Submissions Report Modification 3

SILVERTON WIND FARM

OCTOBER 2016

Project File Name: Silverton Mod 3 Submissions Report v3.1 clean

Figure 5-1 Approved and modified wind turbine envelopes, showing maximum rotor diameters (to scale).

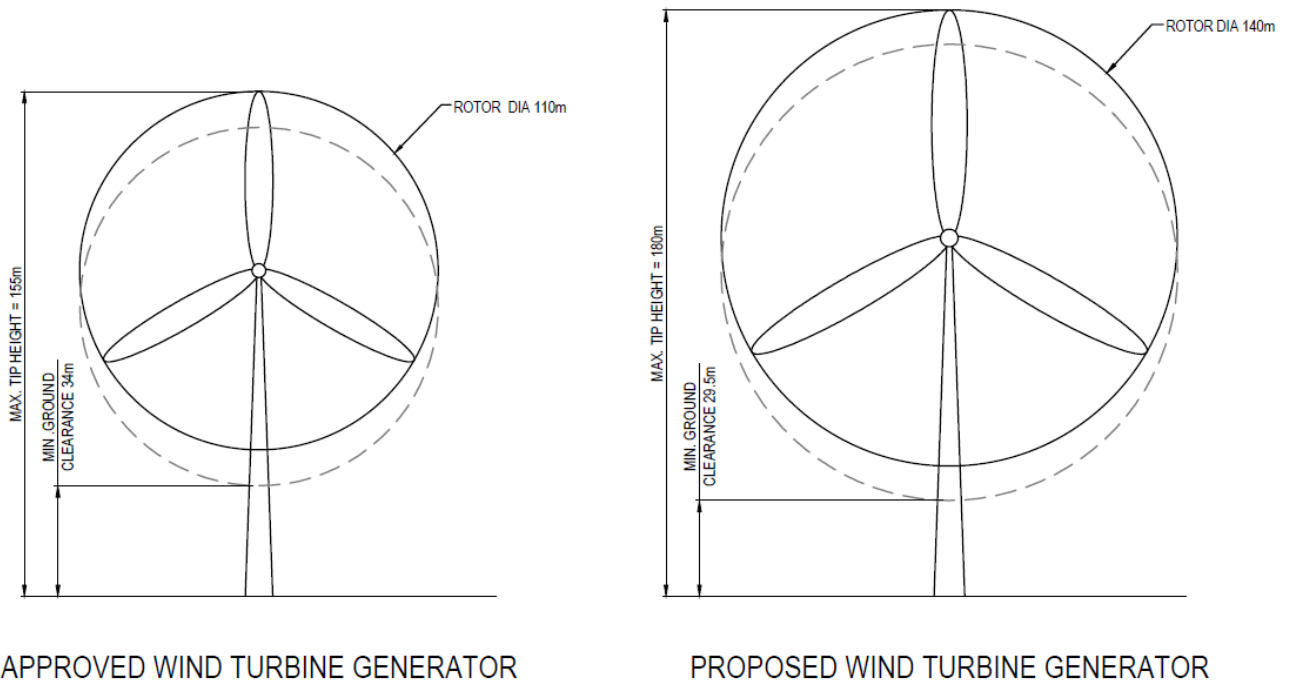
Approval is sought as part of this modification to allow up to approximately 140 meters rotor diameter. Refer to Table 5.1 and Figure 5.1 for the maximum rotor diameter and minimum ground clearance considered in the approved versus Modification 3 layouts.

APPENDIX A MAP SET

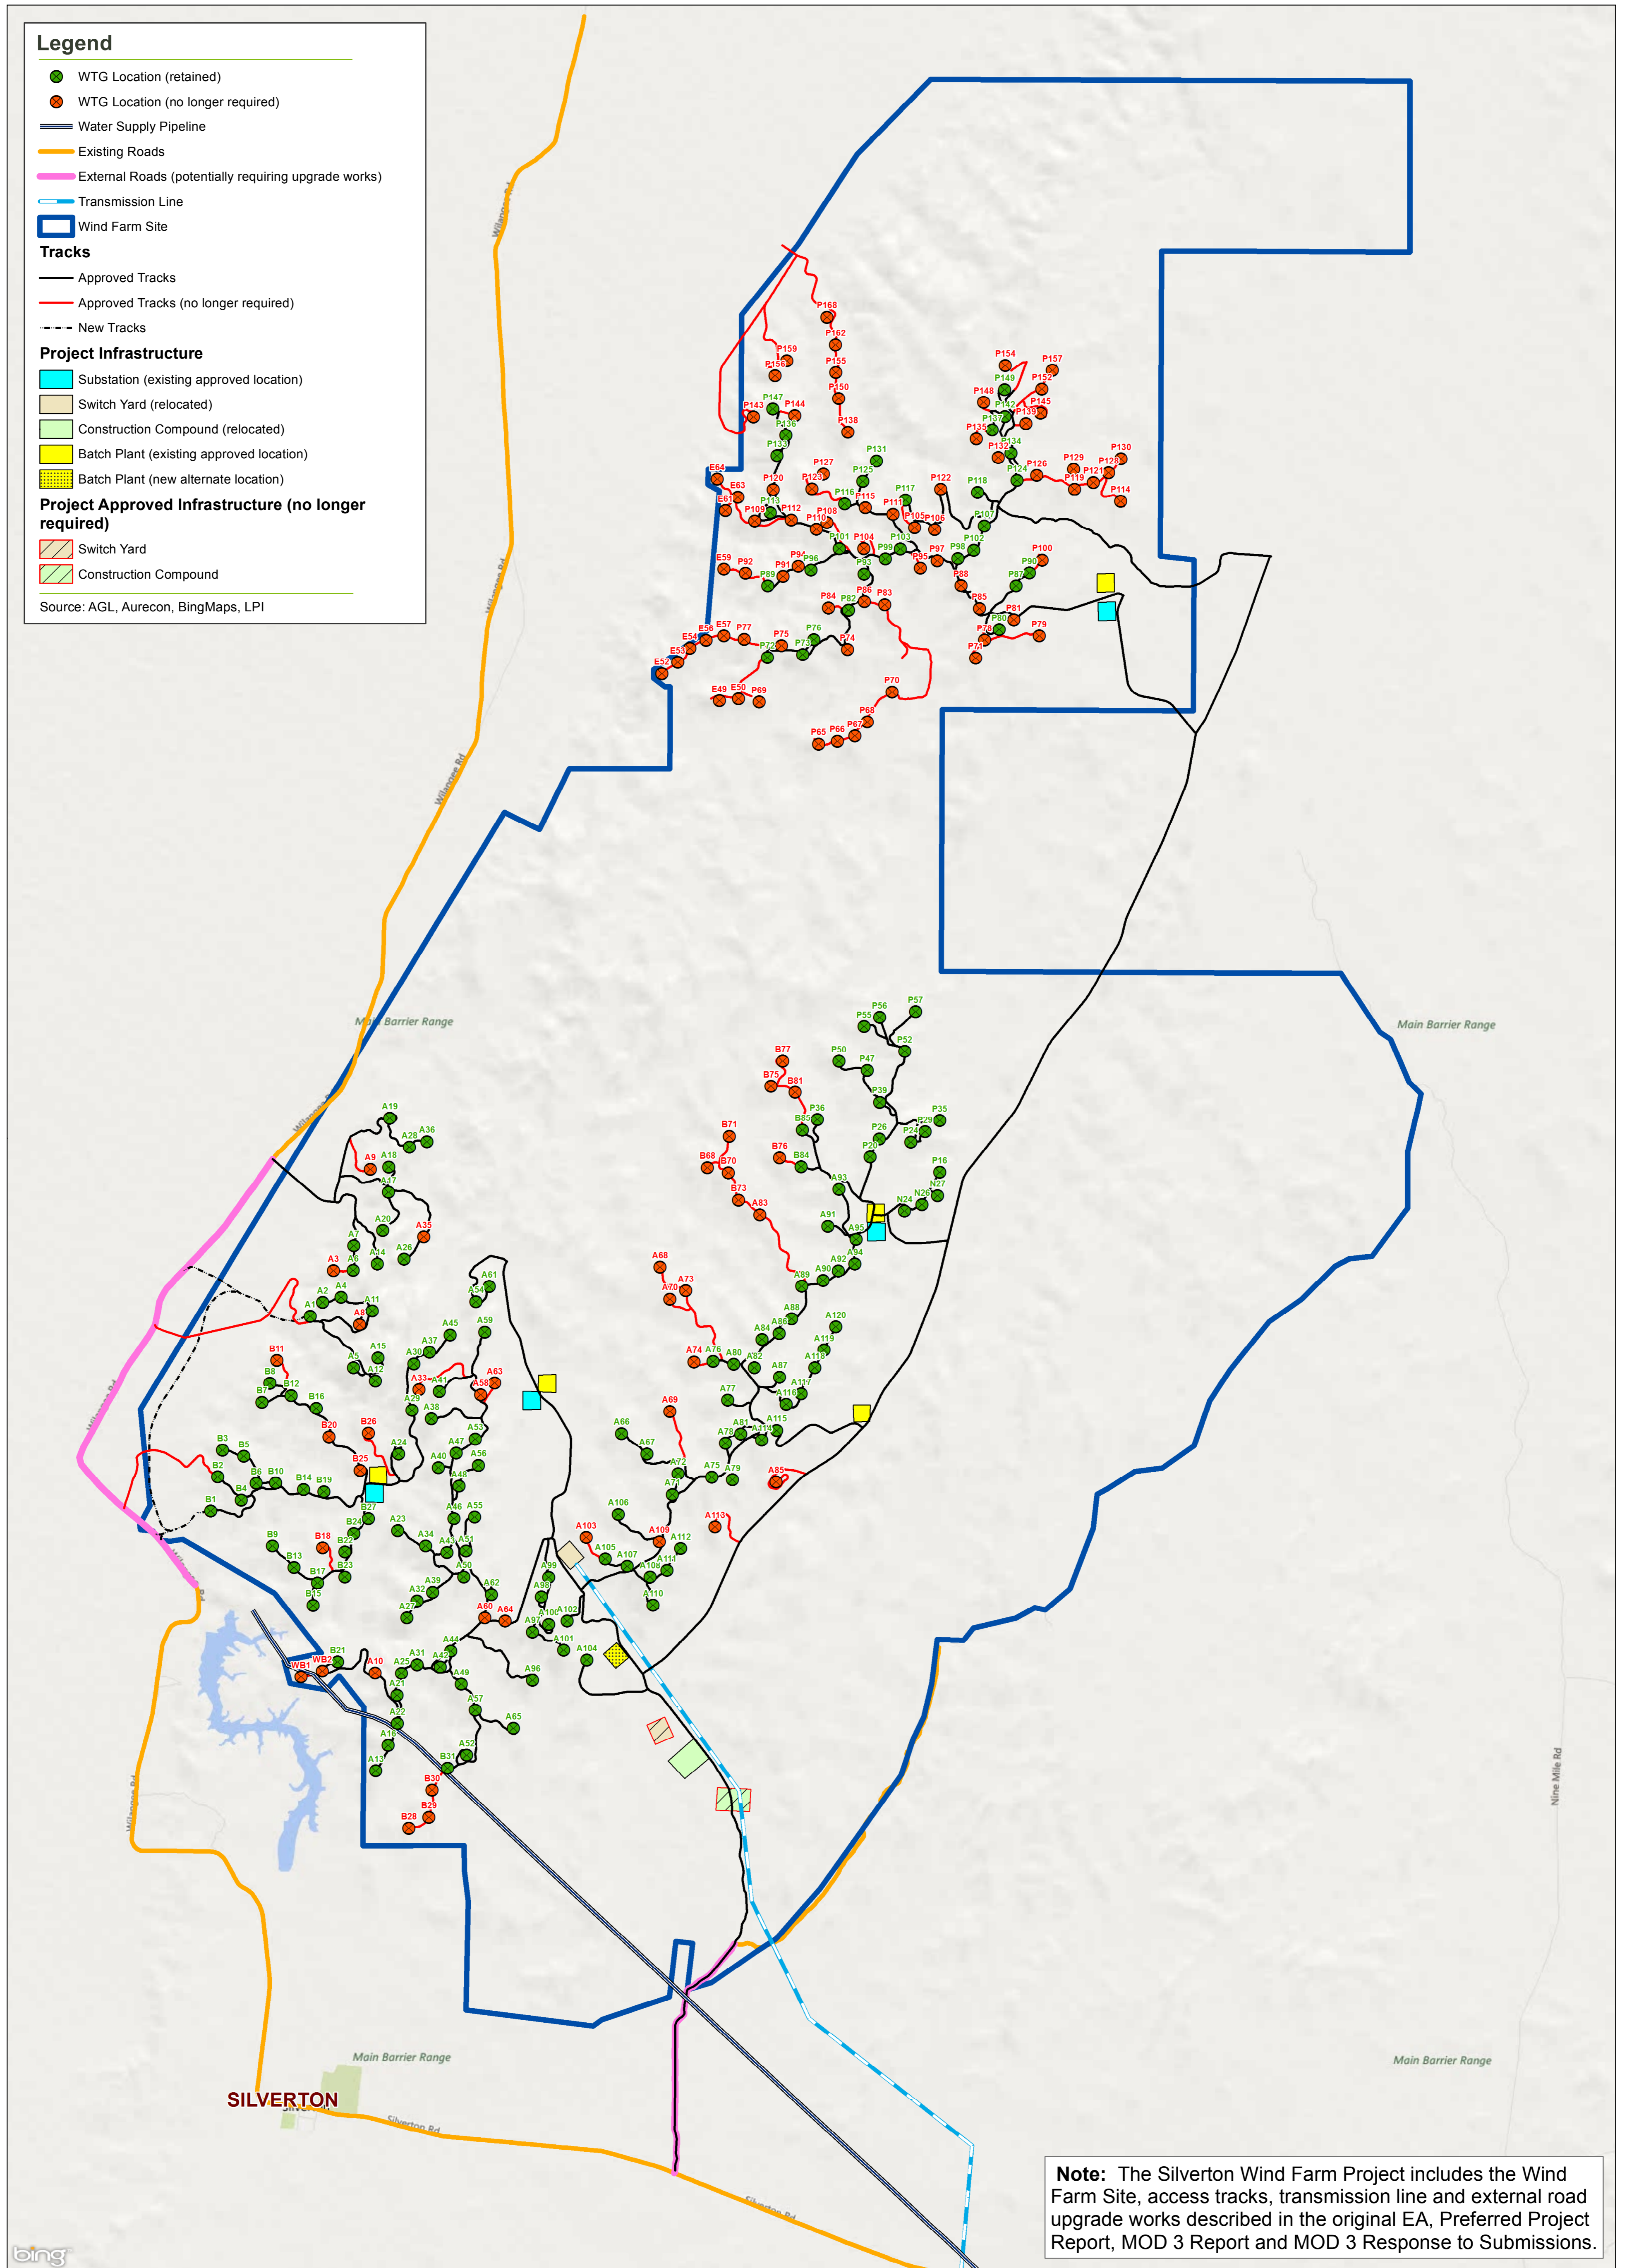
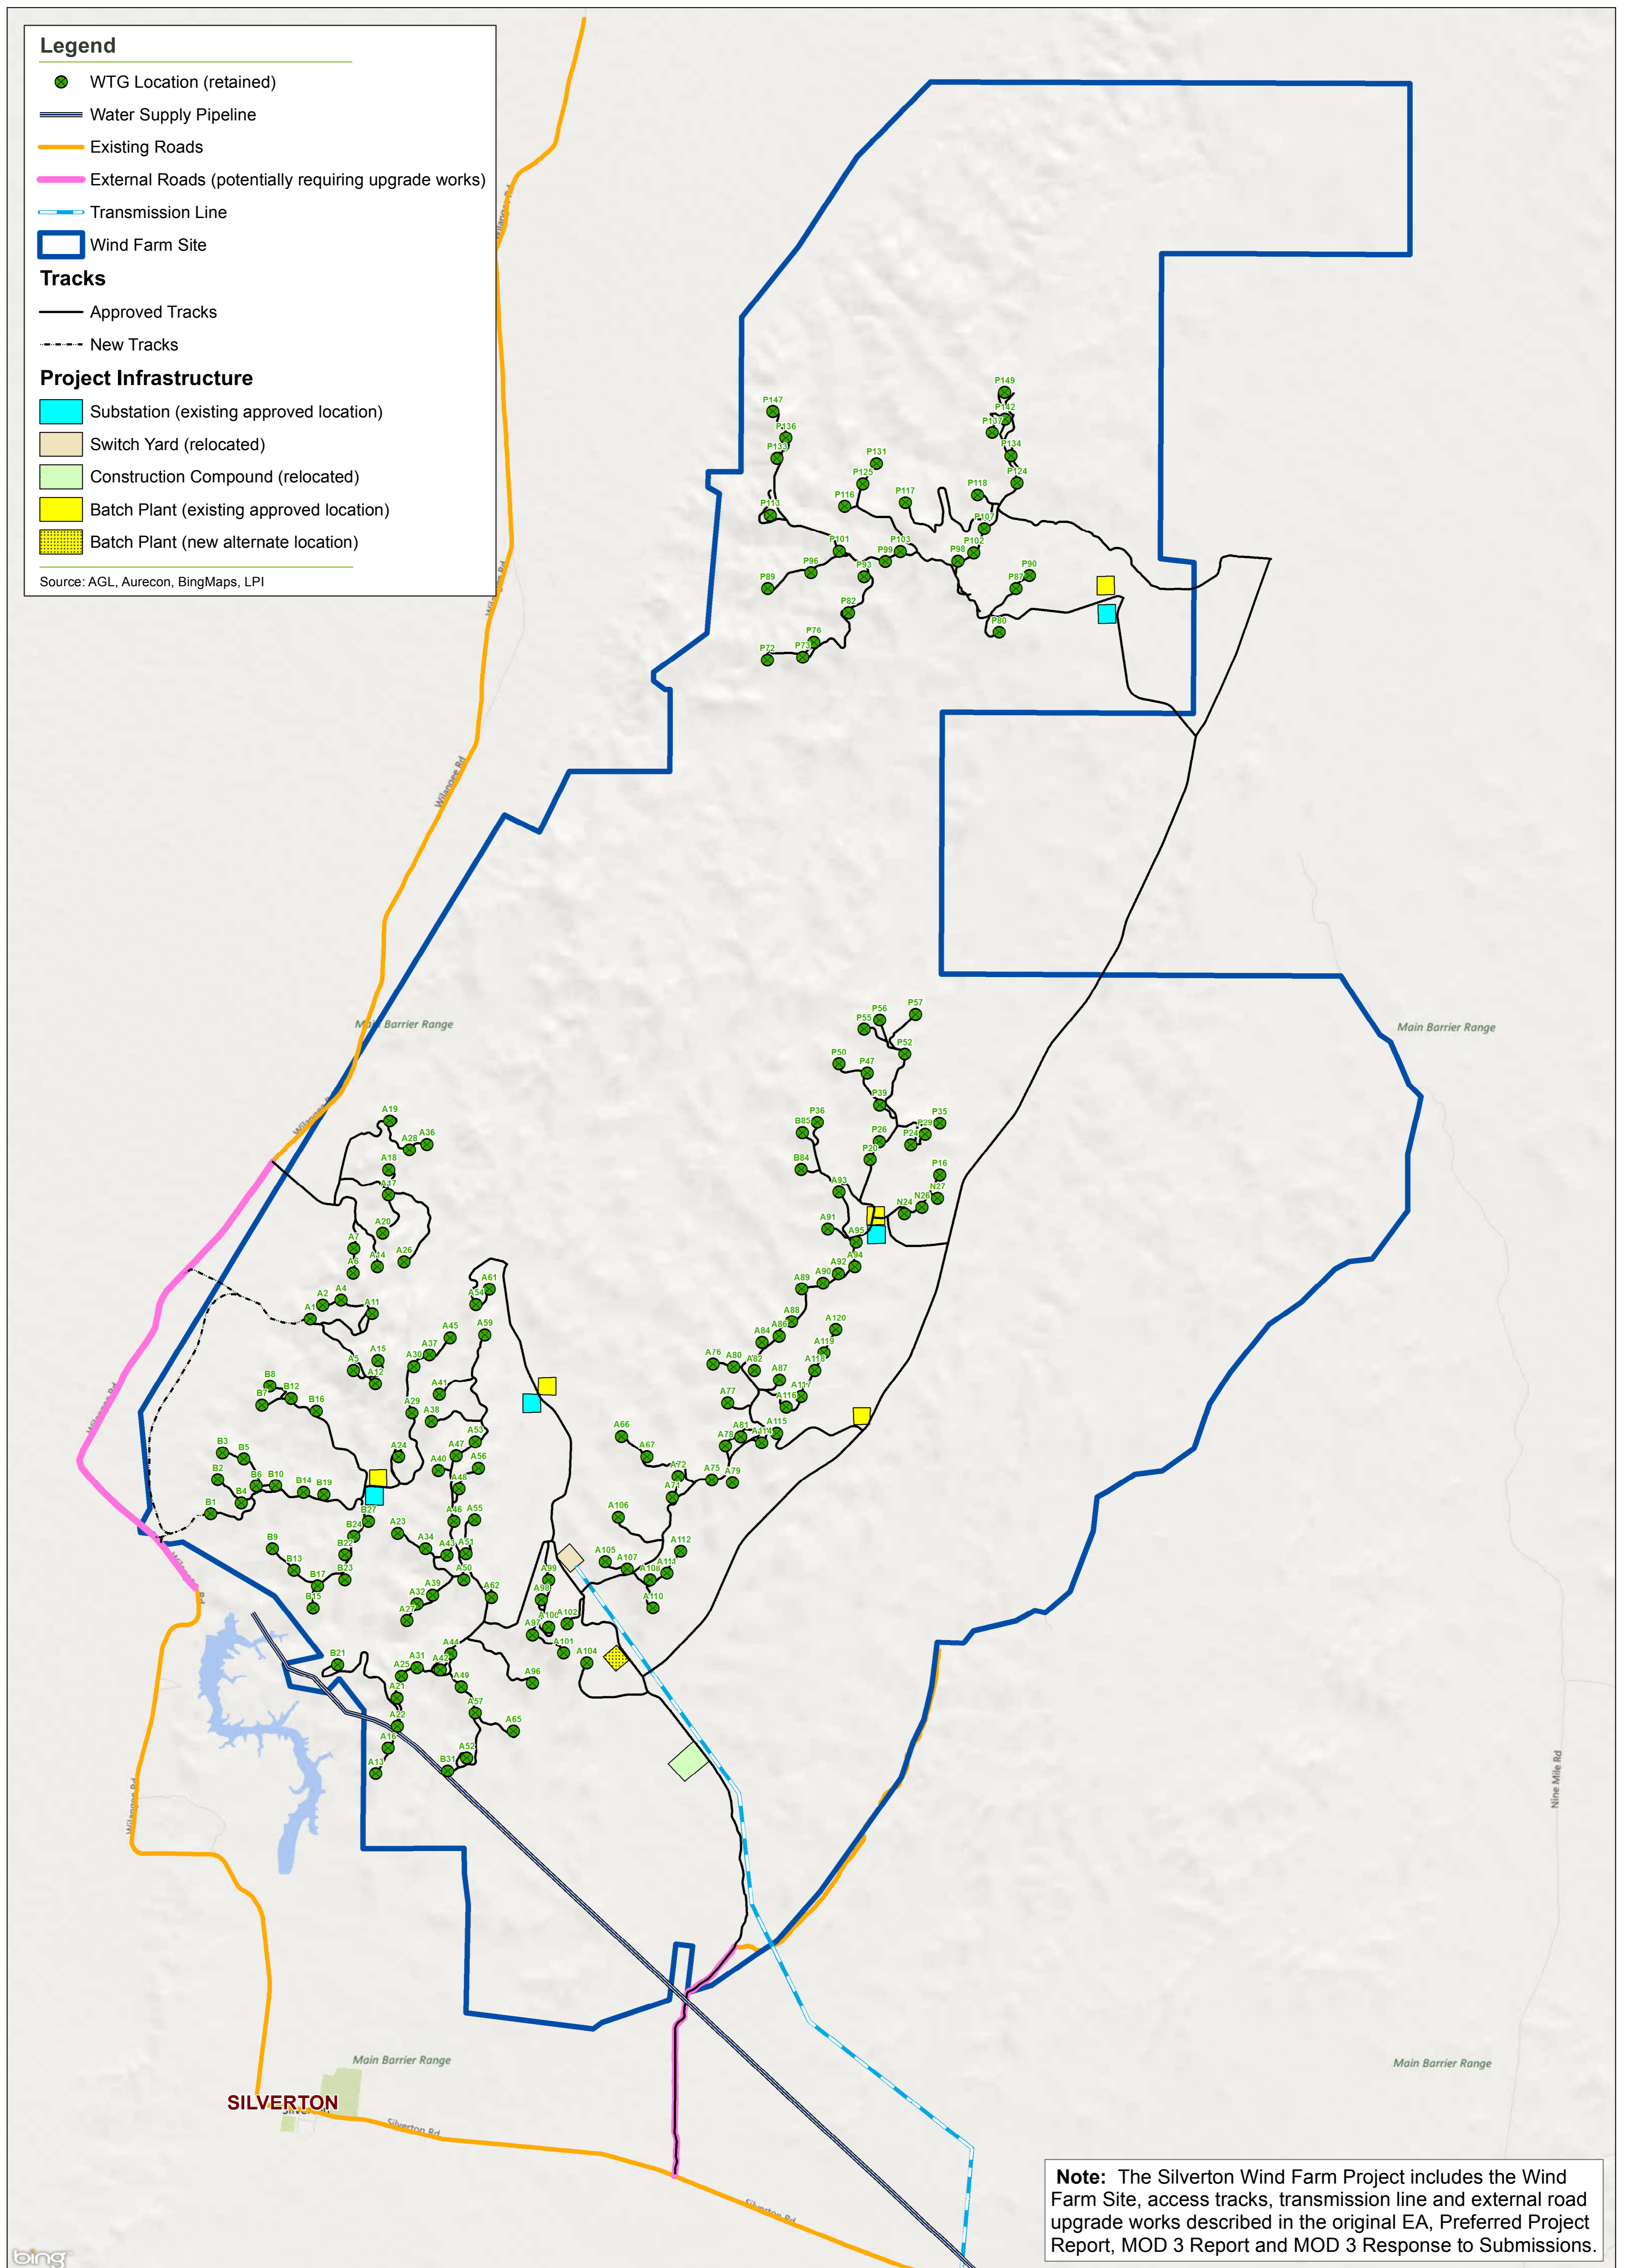
- Includes two tracks to the west of the wind farm site, off Wilangee Road. These tracks were included in the EA (2008) (along with several additional tracks in this area now deleted) were but were not covered in the Modification Report 3. For completeness, these tracks which are likely to be required are now shown on the updated indicative track locations in Appendix A.

This map set has been revised, as described in this Submissions Report, and shows the most up to date indicative infrastructure locations.
